SUBJECT: Forwards addl info required for NRC to complete review of partial penetration weld substitution for sacrificial shield wall. Includes documents re shielding correction for shim gaps at elevation 541 inches to 5 ft & detailed drawings.

Subject: WPPSS NUCLEAR PROJECT NO. 2
NRR APPROVAL OF WNP-2
SACRIFICIAL SHIELD WALL
WELD PREPARATION

SUBJECT: W.O. 2808
WPPSS Nuclear Project #2
SSW Shielding Evaluation Status Report

SUBJECT	SSW Shim Gap Repair
LOCATION	541'-5" SSW: Containment
ENG. SYSTEM	N/A
S/U SYSTEM	N/A
QUALITY CLASS	I

PROTOTYPE TEST FIXTURE
(PLATES TO BE HELD TOGETHER BY "C" TYPE CLAMPS)
FIGURE I (NOT TO SCALE)

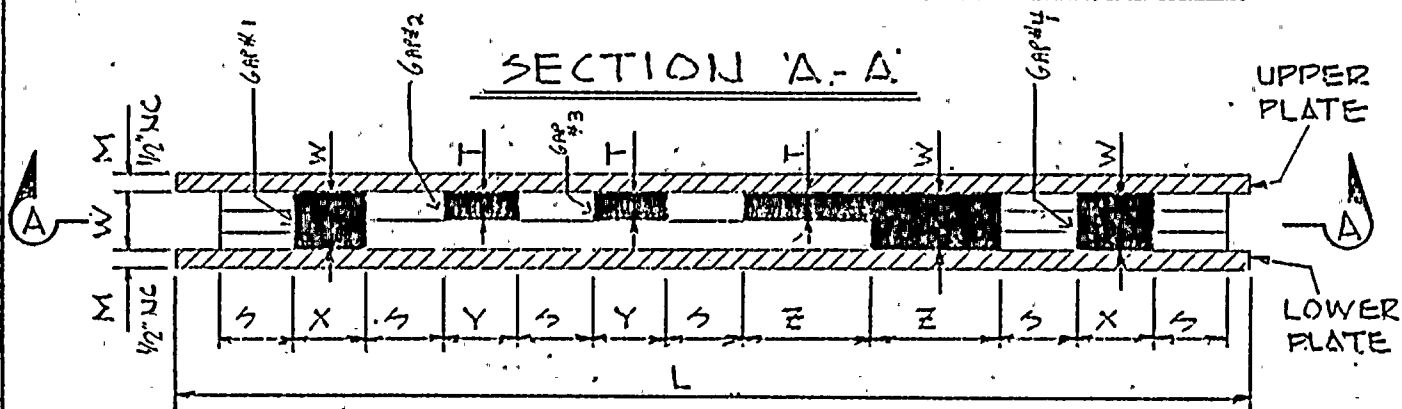
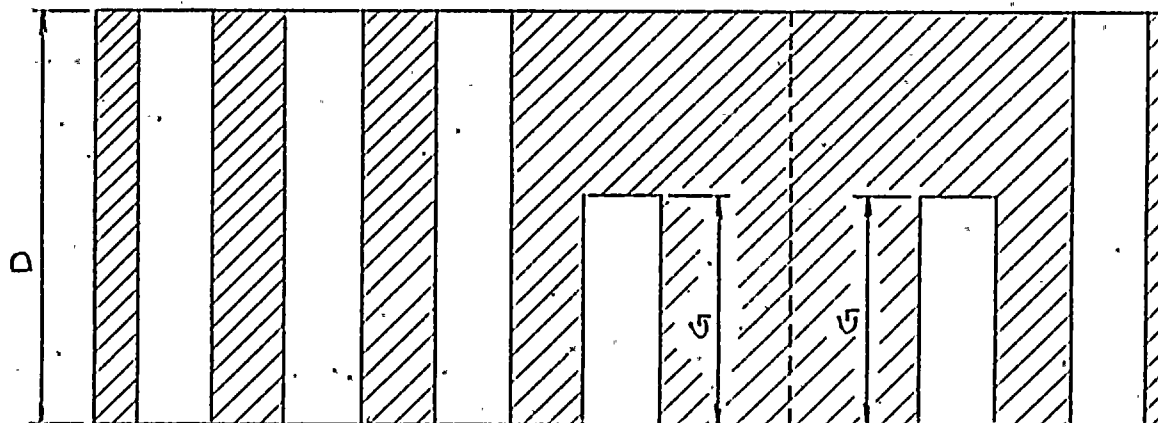
- A. The Owner shall provide two identical test fixtures for PED 215-M-3320 prototype testing of the construction features of the shielding material. Each test fixture shall be capable of simulating four (4) owner prescribed gaps. The test fixture shall consist of two (2) plates for which varying shim stock may be inserted between the plates to simulate gaps between the shims at the 541'5" elevation of the SSW. The plates are held together by heavy duty "C" type clamps. The test fixture and all dimensions are delineated in figure 1 on sheet 3 of 3 of PED 215-M-3320. The gaps prescribed in this figure are indicative of those found per the survey. Each fixture (set of four gaps) shall fulfill the requirement for varying gap sizes as called out in step 3 on sheet 5 of 6.

In all cases it shall be assumed that there is no backing for the flow of the shielding material into the gap. The backing and methodology for inserting backing shall be determined during prototype testing. It is recommended that oil free, steel wool be used for backing the gap, however, other methods suggested by contract 215 or BISCO may be tried to determine feasibility. Any material inserted as a backing (or a dam) for the shielding must be approved by the Owner. The chemical analysis of the backing (or dam) shall be submitted to the Owner for approval.

DOCUMENTS	Brewer on 5/2/80																																																																																	
DESCRIPTION OF WORK: 1. (a) Sheet 3 of 6 of PED 215-M-2746 requires (in two places) the transmittal of documentation to the owner for approval prior to procurement of the shielding material. This requirement shall be implemented for the shielding material to be installed in the SSW and does <u>not</u> apply to shielding material required on site for prototype testing. The purpose of this PED is to clarify the intent of those statements so as to expedite the initiation of prototype testing. (b) In line with the above, Contract 215 is authorized to have the prototype testing shield material air-freighted to the site to reduce the delivery time. 2 (a) Revise sheet 4 of 6 of PED 215-M-2746 as per sheet 2 of 3 of this PED. (b) Refer to figure 1 on sheet 3 of 3 of this PED. This figure delineates the test fixture required to perform prototype testing as called out in Sheet 2 of 3 of this PED. <p style="text-align: center;">*** Note that two (2) test fixtures are required by this PED. ***</p>
